**CARGILL
DOMESTIC SOYBEAN
PROCESSING**

United States Nuclear Regulatory Commission
Materials Licensing Section
Control # 79629
799 Roosevelt Road
Glen Ellyn, Illinois 60137

Enclosed is the information on the three (3) categories we discussed on September 4, 1985.

Application #1
Extractor Discharge Hopper
(Cross-Sectional View)

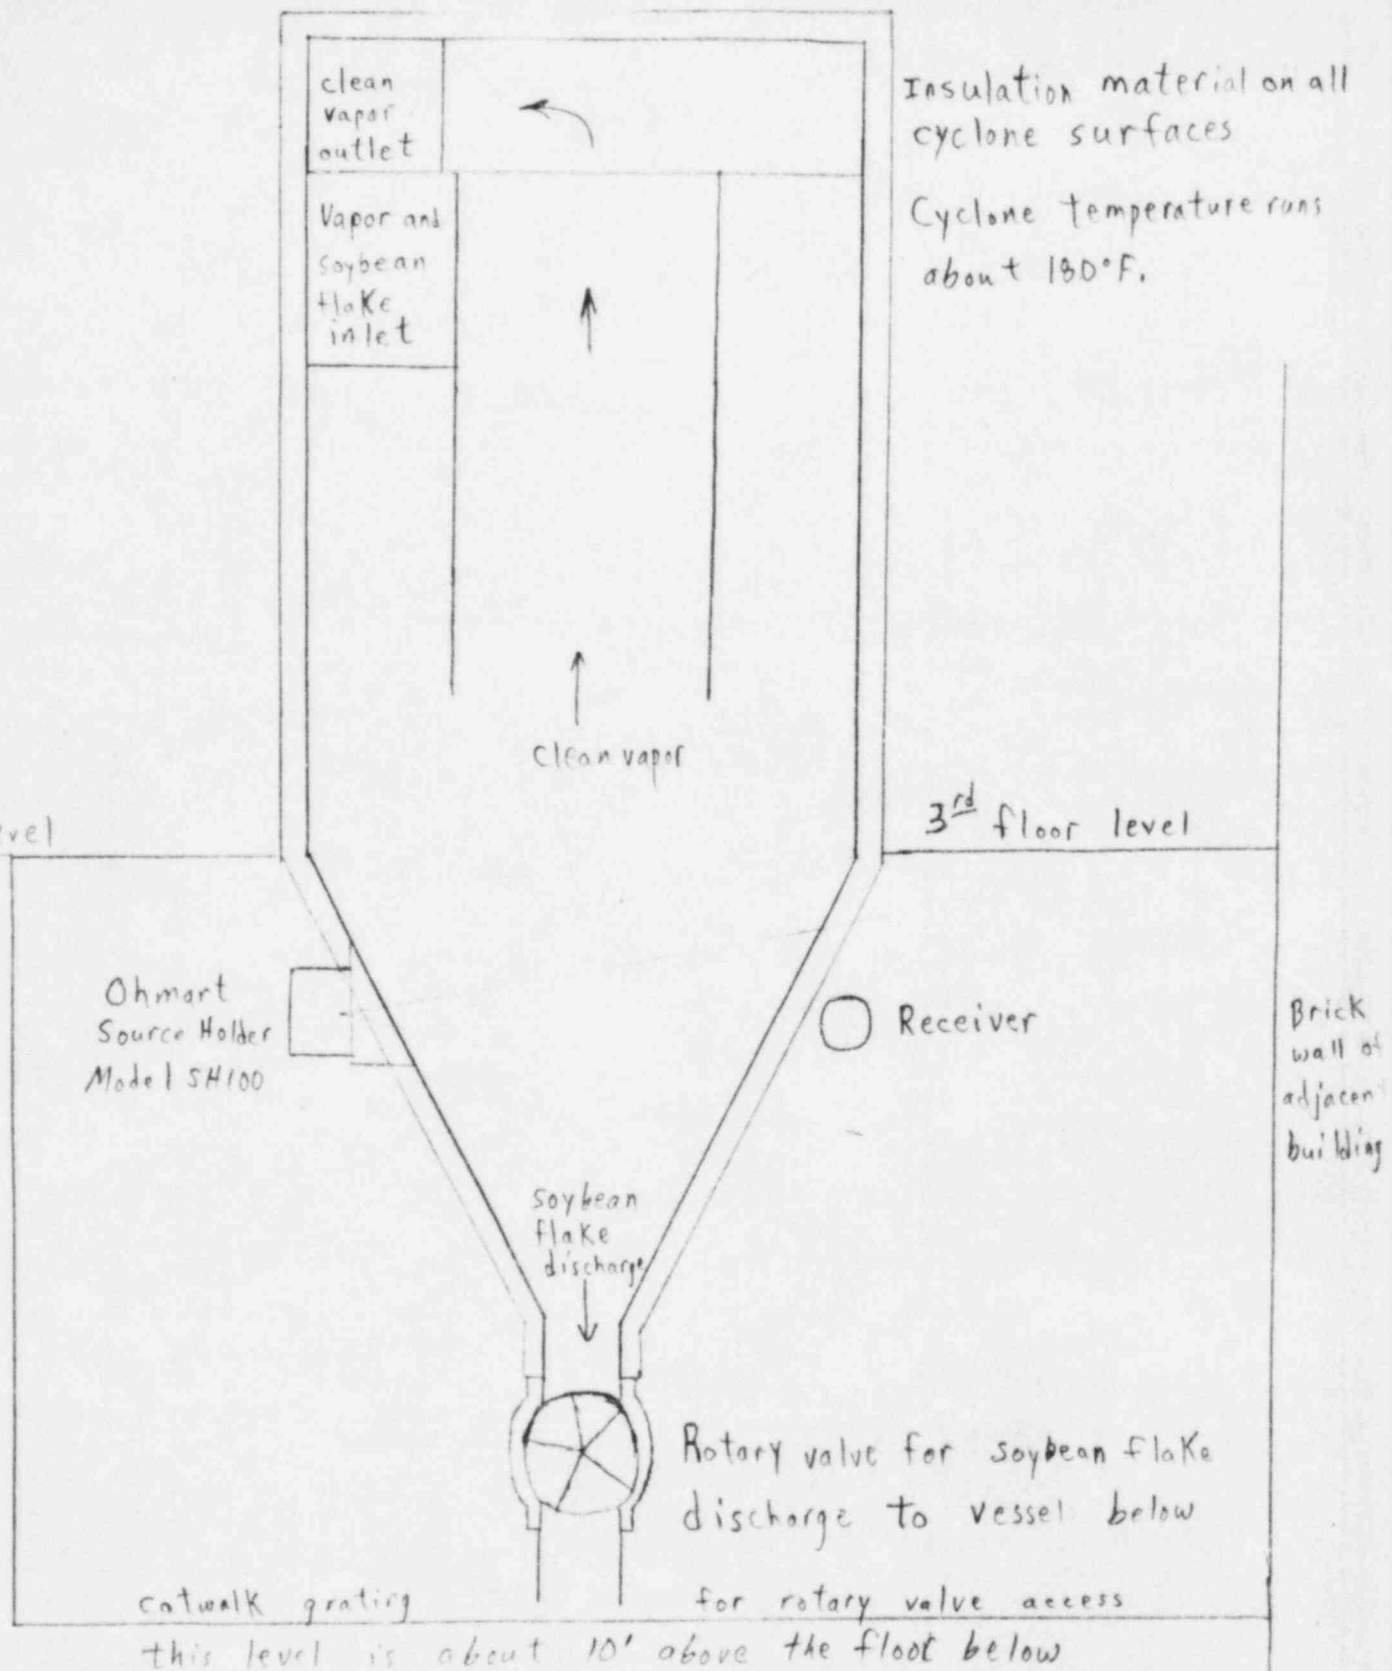
- 1) Need sketch of proposed location of each gauge, plus indication of access to and control of
- 2) Describe environmental conditions to which gauge will be exposed, cooling system? if so need description of methods and procedures for detecting failure and procedures for coping with failure
- 3) Describe/submit lock-out procedure ~~add~~ Item 10.5 of RG

1. A sketch of each application is enclosed. The area within 3 to 5 feet of each source holder is air space.
2. No corrosive type atmosphere will be present around source holder. The air temperature around the source holder will range from 70°F to 100°F, depending upon the season of the year. The process vessel temperature in application #1 is 140°F and in application #2, the process vessel temperature is 180°F. The manufacturer has indicated there is no need for a cooling system on the gage source.
3. Signs on or near the vessel entry doors indicating a radiation area will be posted. A source lockout procedure will also be posted with the radiation sign. All persons who remove doors on the process vessels or enter the vessels must first check to see that the source shutter is locked in the closed position. The lockout procedure will be reviewed on an annual basis with all employees.

Normal flake level when compartment is emptied from above vessel.

Ohmart Source Holder Model SH 100

Source will be located about 10' above 4th floor level.
